**CITY OF TEMPE
DEVELOPMENT REVIEW COMMISSION**

**Meeting Date: 12/12/2017
Agenda Item: 4**

ACTION: Request for a Development Plan Review for a new six-story multi-family development containing 171 dwelling units and ground floor commercial uses for **FARMER ARTS DISTRICT – PARCEL 1, LOT 1**, located at 707 South Farmer Avenue. The applicant is Huellmantel & Affiliates.

1 DPR WASTE REFUSE PLAN
1" = 20'-0"

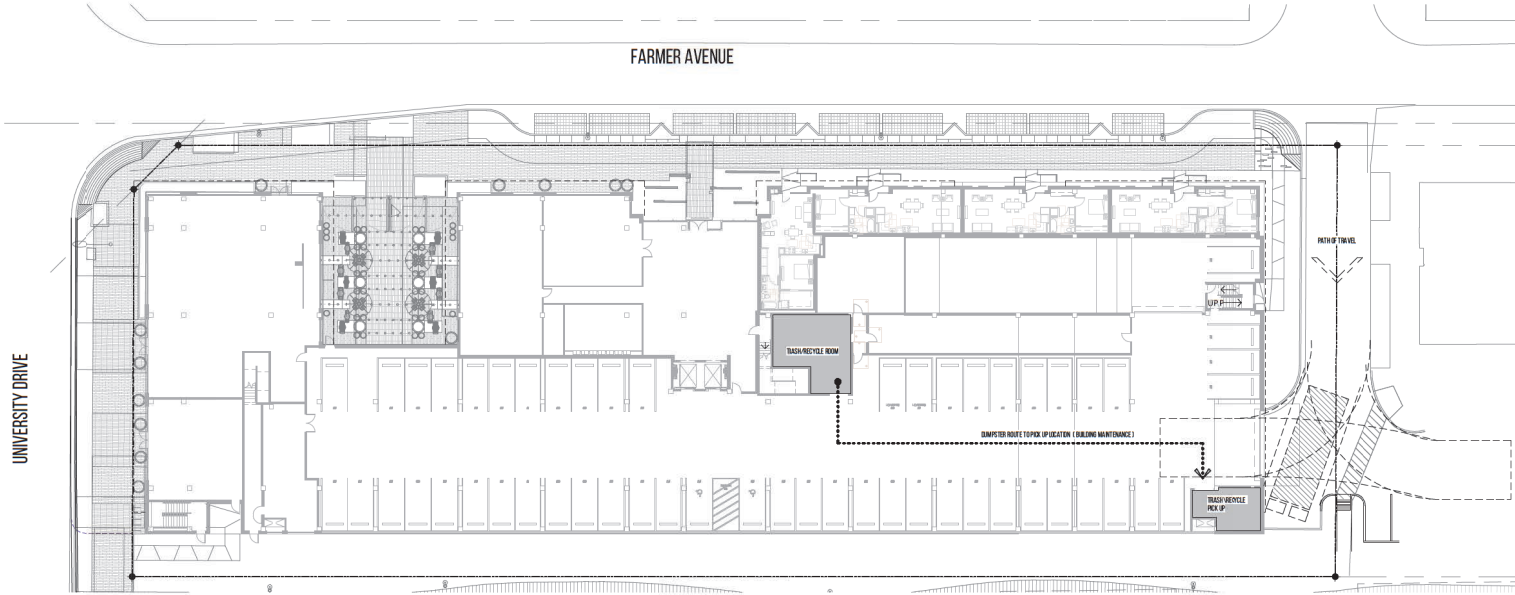
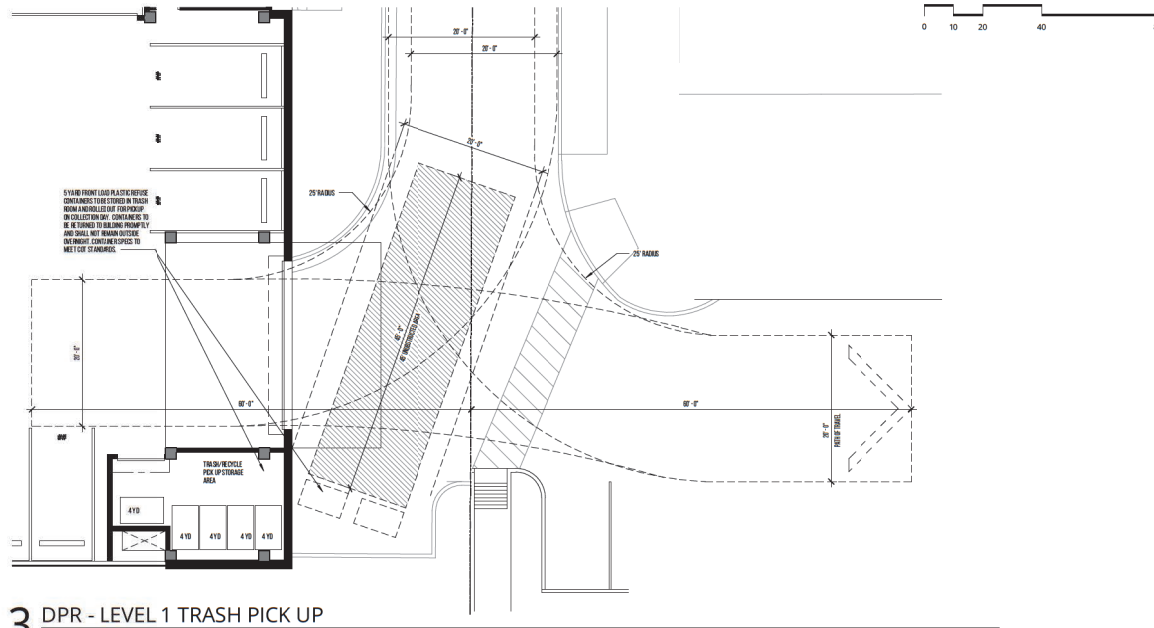
7. Refuse plan is approved as shown for both trash/recycle collection and staging for pick-up, on plan dated November 29, 2017 (Attachment 25, Sheet A-1.02).

FACADE DETAIL

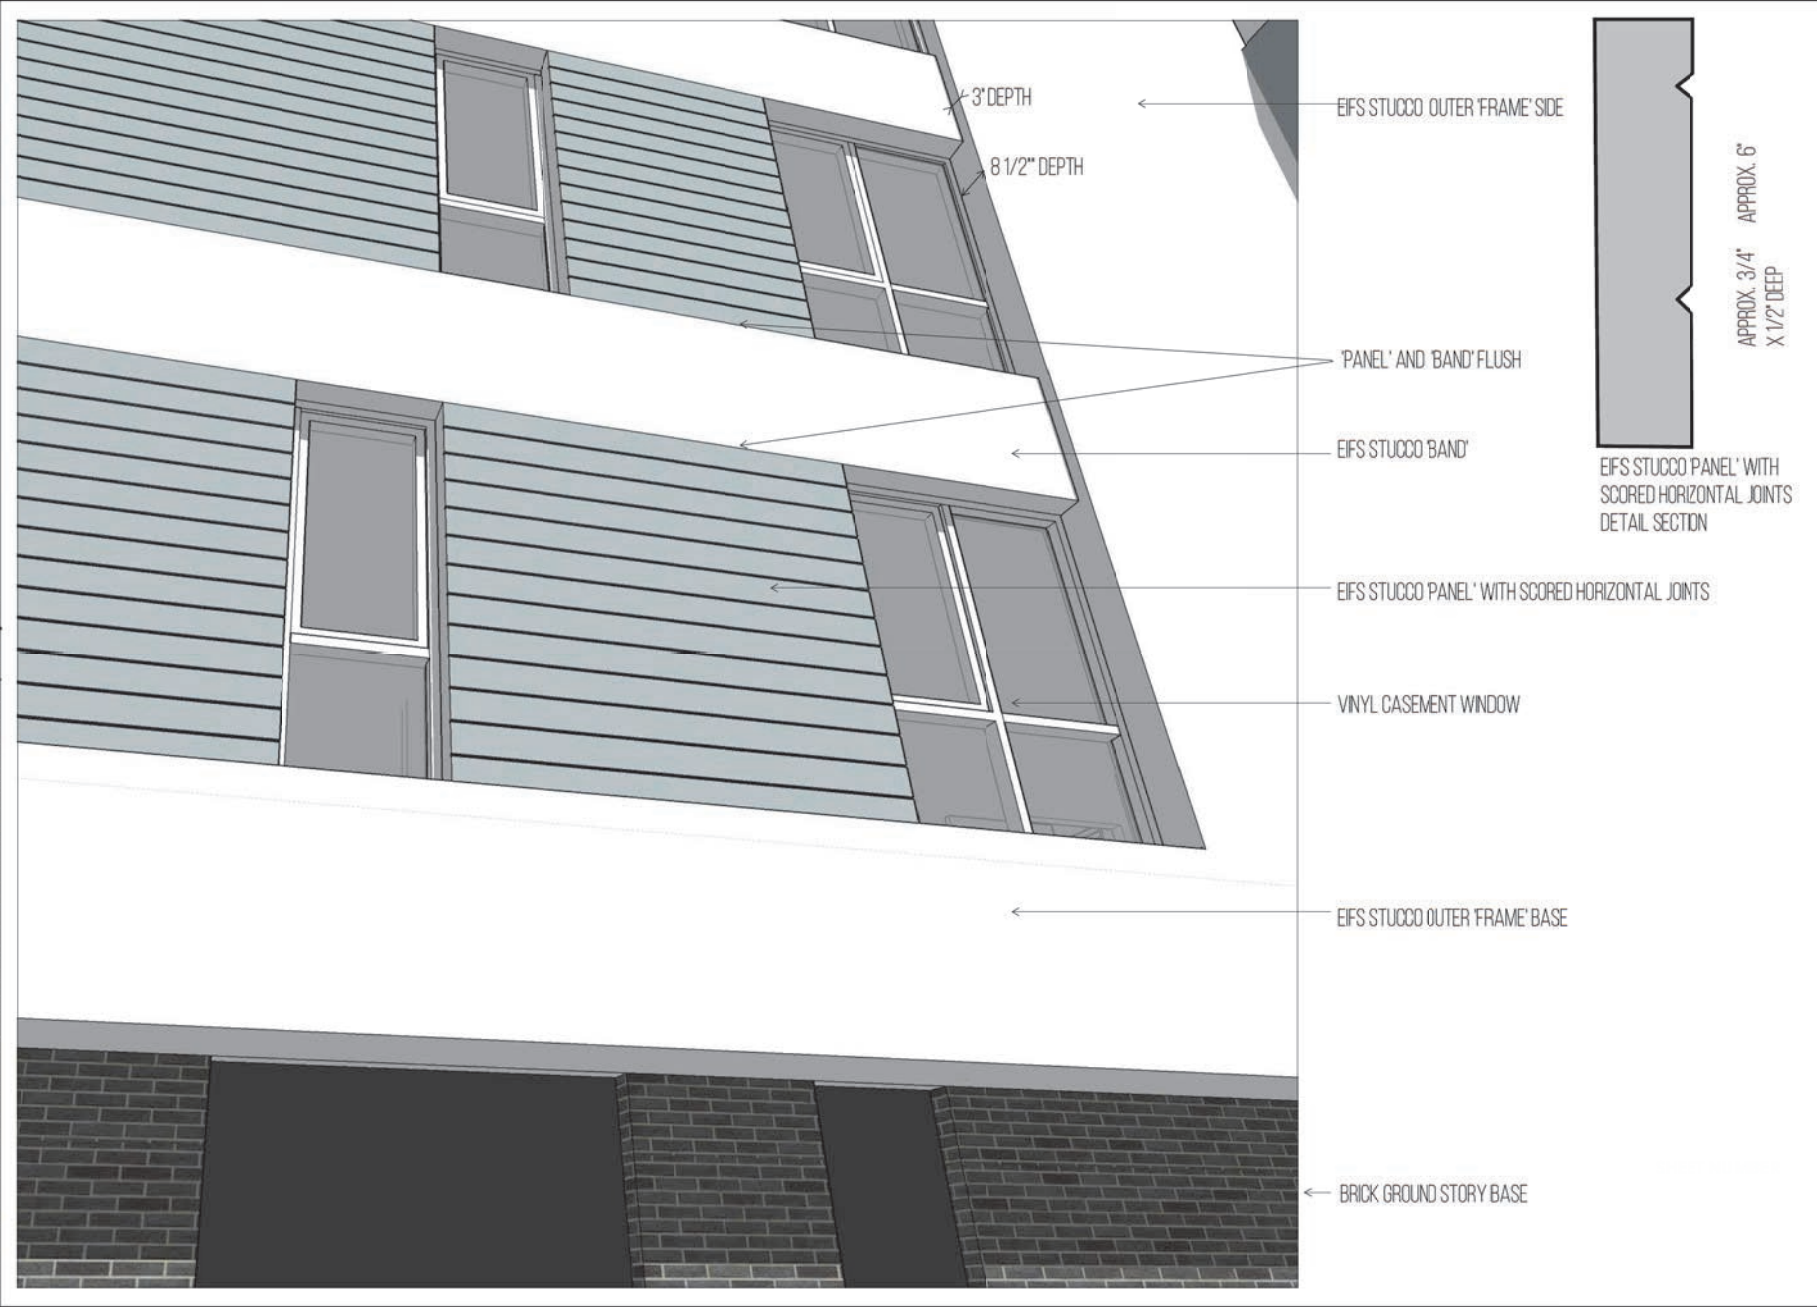
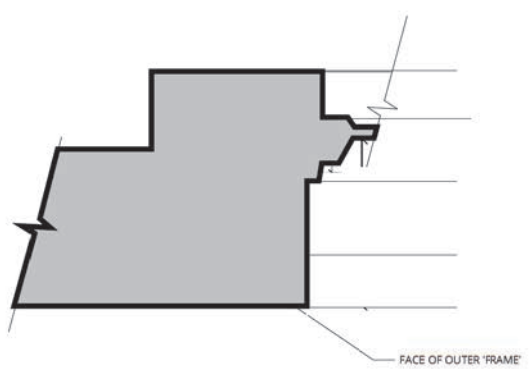
21. Provide a minimum 5" and 8.5" deep recess to windows located on the south and west building façades. Refer to Attachment 33 (Sheet labeled Façade Detail) for compliance.

22. Portions of building where scoring is shown, must meet detail shown on Attachment 33 (Sheet labeled Façade Detail).
23. Provide secure roof access from the interior of the building. Do not expose roof access to public view.
